## Product Change Notice (PCN)

**Subject:** Bonding-wire change to Cu-wire and site addition of Back-Grinding, Assembly and Final Test for the RH850/F1 and D1 series.

**Publication Date:** 12/28/2021

## Cu-wire product identification

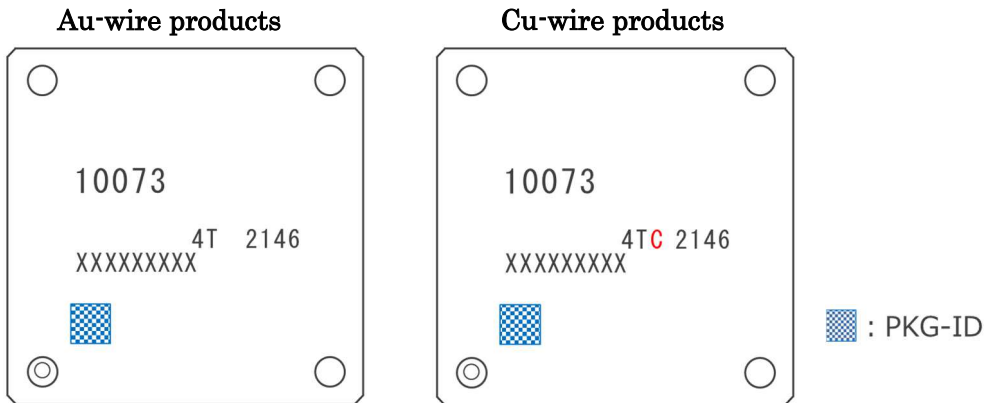
### Product identification for Cu-wire products through mark print on each PKG

Mark example: ATJ-Kumamoto products for F1L-2M 176pin

Mark comparison between R7F7010073AFD#BA4(Au-wire) and R7F7010073AFD-**C**#BA4(Cu-wire)

“**C**” (The red character) is added in a part of the mark for the laser mark of Cu-wire products

### Product identification for Cu-wire products through label print

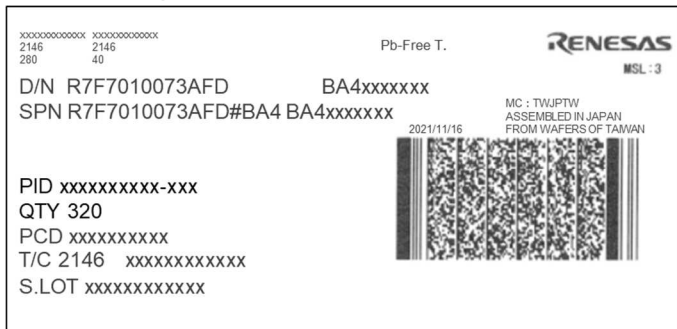
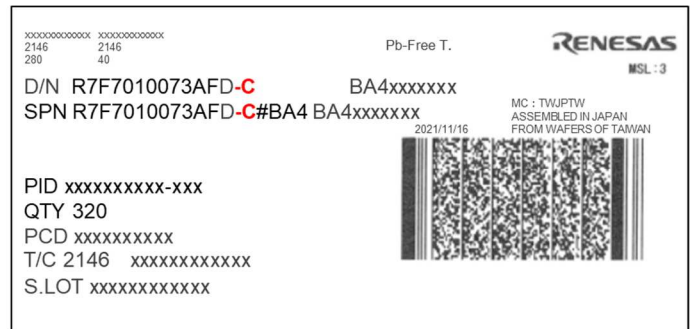
Label example: ATJ-Kumamoto products for F1L-2M 176pin

Label comparison between R7F7010073AFD#BA4(Au-wire) and R7F7010073AFD-**C**#BA4(Cu-wire)

#### Label image for Au-wire products

#### Label image for Cu-wire products

The red characters are different.

RH850/F1L, F1M, F1H, F1K, D1L1 and D1L2 series

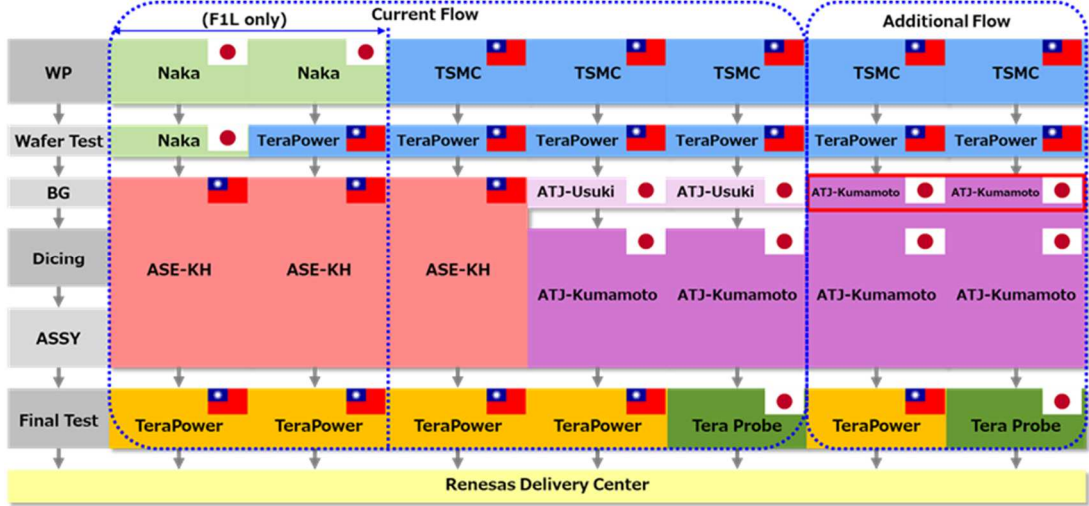
**Additional sites**

RH850/D1S1-V2 series

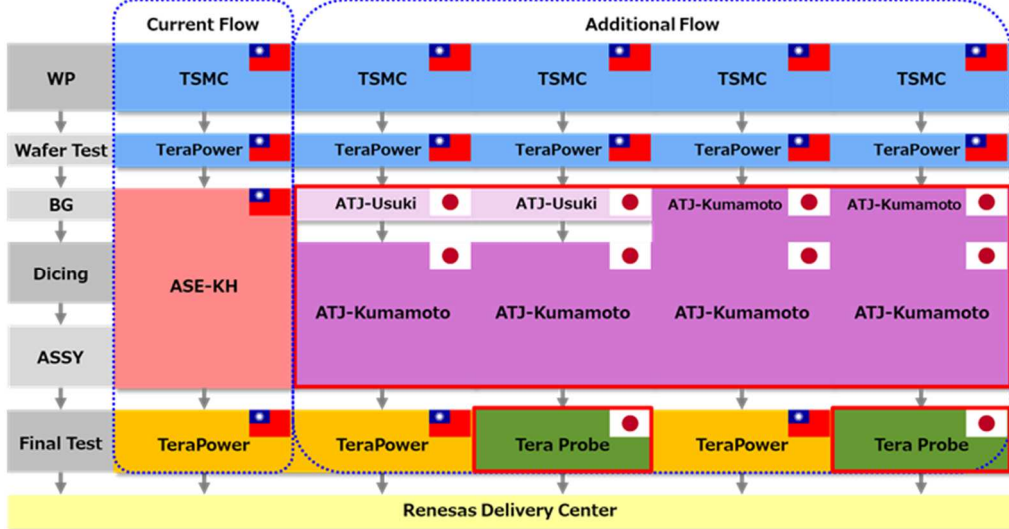
Au-wire(Before change)	Cu-wire(After change)	Remarks
Production sites	Wafer process	w/o change		Refer to "Production Flow"
	Wafer Test	w/o change		
	Back Grinding	ATJ-Kumamoto/ATJ-Usuki addition		
	Assembly	ATJ-Kumamoto addition		
	Final Test	TPJ addition *1		
Materials	PAD-opening( $\mu$ m)	w/o change		
	Wire-bonding materials	Au-wire	Cu-wire	*2
	Mold-resin materials	Mold-resin for Au-wire	Mold-resin for Cu-wire	
	Die-attach materials	ASE-KH standard materials	ASE-KH/ATJ-Kumamoto standard materials

RH850/F1KM series

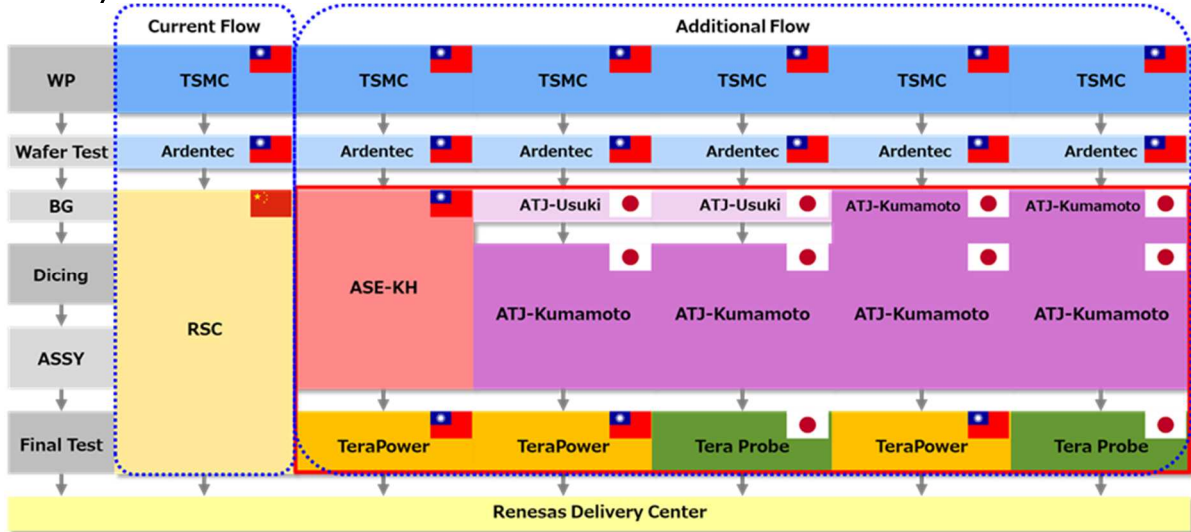
Cu-wire(Before change)	Cu-wire(After change)	Remarks
Production sites	Wafer process	w/o change		Refer to "Production Flow"
	Wafer Test	w/o change		
	Back Grinding	ATJ-Kumamoto/ATJ-Usuki addition		
	Assembly	ASE-KH/ATJ-Kumamoto addition		
	Final Test	ASE-KH/TPJ addition *1		
Materials	PAD-opening( $\mu$ m)	w/o change		
	Wire-bonding materials	w/o change		
	Mold-resin materials	RSC standard materials	ASE-KH/ATJ-Kumamoto standard materials	
	Die-attach materials	RSC standard materials	ASE-KH/ATJ-Kumamoto standard materials
